Staff Summary Report

SUBJECT: This is a public hearing for a request by **AGAVE CENTER - CARL'S JR. RESTAURANT (PL090412)** located at 8825 South Jewel Street for two (2) variances.

DOCUMENT NAME: 20110906kko01 **PLANNED DEVELOPMENT (0406)**

AGAVE CENTER - CARL'S JR RESTAURANT (PL090412)

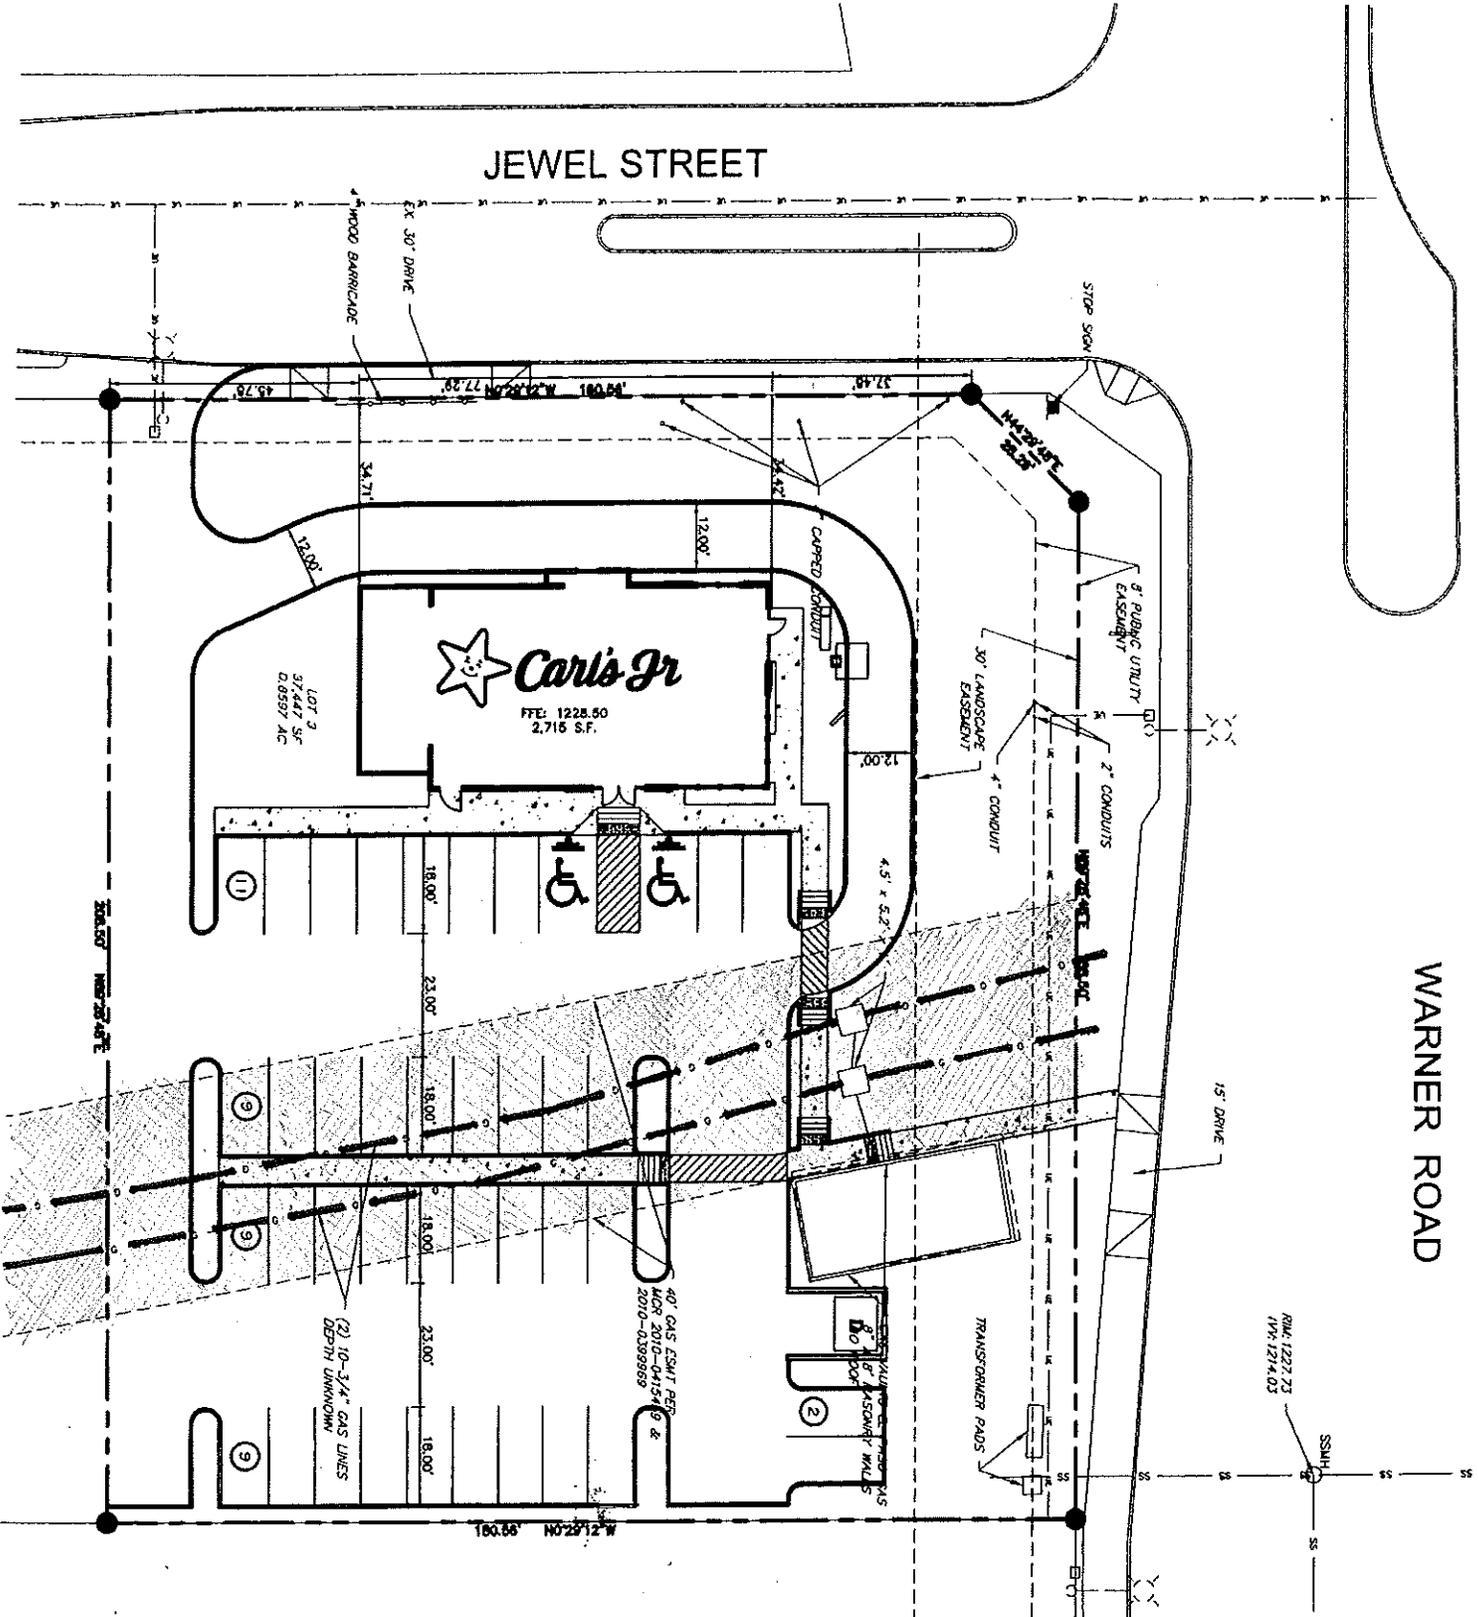
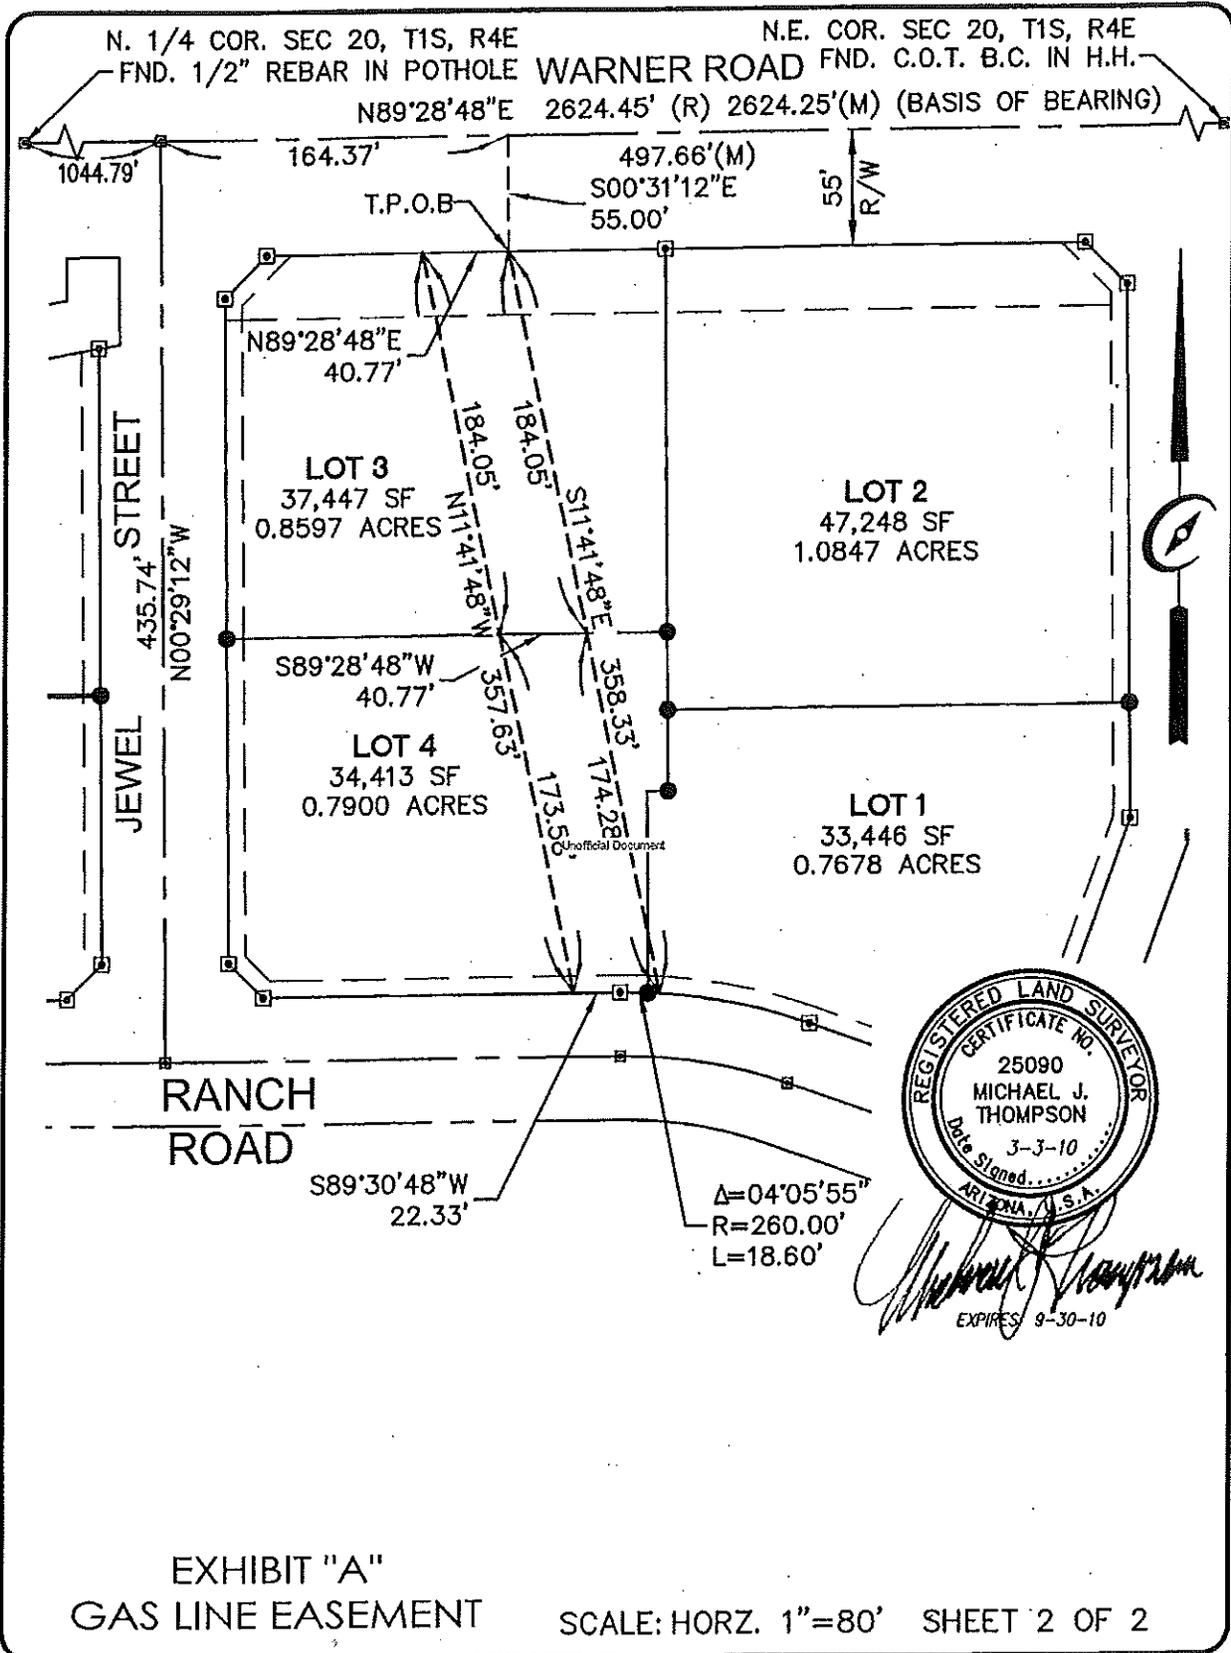
6. Promptly repair damage to paving and landscape caused by periodic heavy maintenance to gas lines contained under the natural gas easement.
7. The site parking layout with dimensions as indicated does not meet the minimum standards of the Zoning and Development Code (ZDC) with respect to fire/refuse lane layout (item d. below) and landscape island size (item e. below). Incorporate the requirements of items a., b. and c. below and make adjustments to the site plan to correct the parking layout.

- a. Minimum standard parking space is 8'-6" wide and 18'-0" long, but 2'-0" of parking space length may overhang adjacent paved walkway or landscape in accordance with ZDC Sec. 4-606(A.1.). At a walkway, provide minimum 4'-0" access width on paving outside of parking space overhang.

- b. Minimum disabled van accessible parking space width is 8'-0" with an 8'-0" side aisle in accordance with COT Engineering Standard Detail T-360.
 - c. Maintain minimum 23'-0" wide two-way drive aisle width in accordance with ZDC Tab. 4-606A.

- d. On the site plan indicate outline of 20'-0" wide fire and solid waste lane through parking lot in accordance with ZDC Fig. 4-502(G). Locate fire lane entirely in drive aisle. Maintain fire lane entirely clear of landscaped island curbs and parking spaces. Do not provide turn radius that is less than the minimum allowed.

- e. Provide landscaped islands of minimum size and area in accordance with ZDC Sec. 7-704(C.2.).
